What's New

Kenmore

New HE Dishwasher

New Product Introduction

New HE wash system

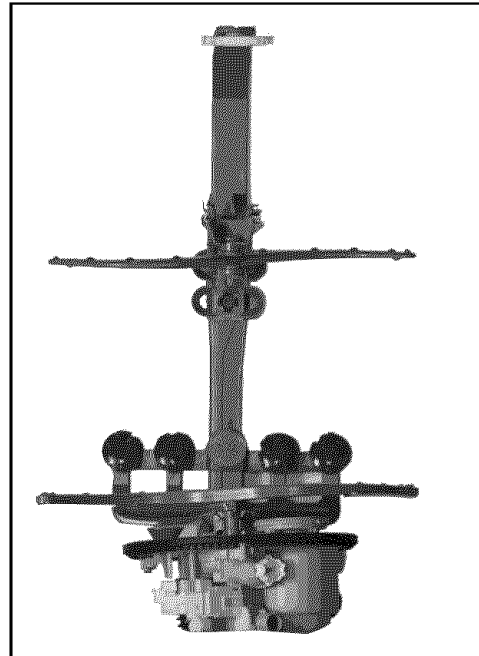
This new wash system has been designed to achieve higher energy efficiencies while maintaining superior wash performance. In order to achieve this, changes were made to the wash process and to the sump assembly.

Alternation Wash operation

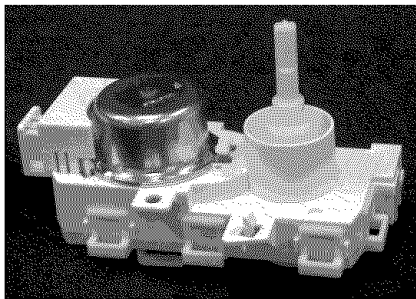
The alternating wash operates in the following modes:

For all wash cycles the upper spinner³ is always active.

The lower spray arm¹ and middle spray arm² will alternate every 1 to 4 minutes depending on what part of the wash cycle the dishwasher is in.

The Turbo Zone option⁴ runs independently

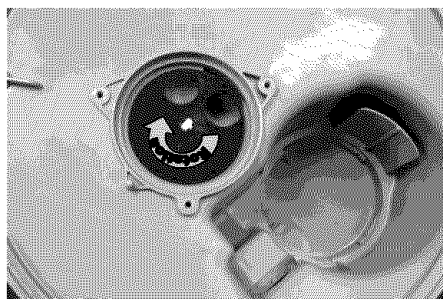
Wash alternation is accomplished through the use of a diverter motor (left) and the diverter disc (right). Both are used throughout the wash cycle to maintain the correct water path.

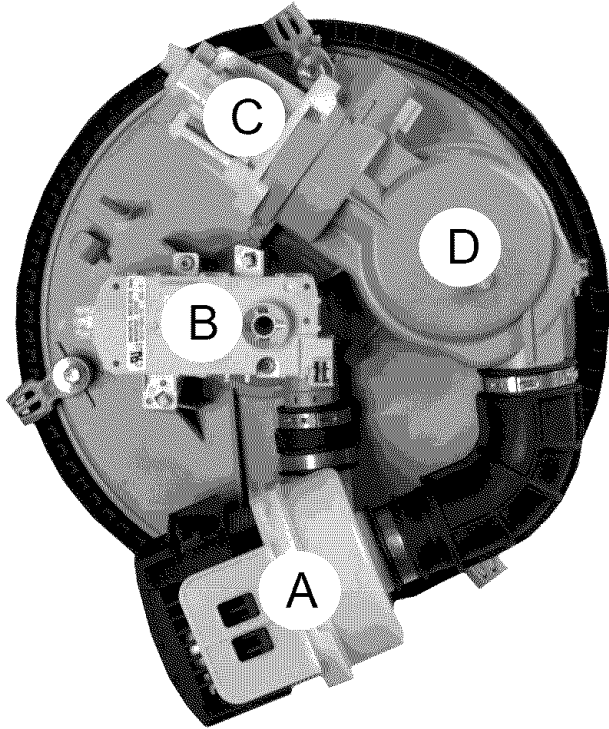
The new sump system to the left shows the location of each of the parts.

The variable speed motor used allows for “soft” starts reducing noise and controls water pressure more effectively.

The diverter motor allows alternation of the wash without interrupting the cycle.

The drain pump (unchanged).

The sump which is smaller because of the less amount of water used.
